DESCRIPTIVE REPORT

Field No. 746-10-1-66 Office No. H-8878

General locality Hampton Roads

HYDROGRAPHIC SURVEY REVIEW

DEVELOPMENT #3

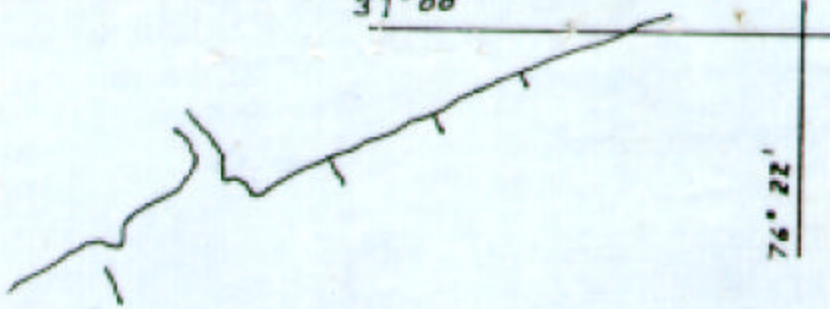
The area around the 5 ft. sounding at Lat. $36^{\circ} 59.43'N$, Long. $76^{\circ} 22.38'W$, (H-4078), was developed carefully and a depth of $6\frac{1}{2}$ feet was the shoalest recorded (development #3-- overlay). *Sndg Vol. shows least depth to be 6.8' Recorded on Survey as 7'*

Plotted on
Smooth
Sheet.
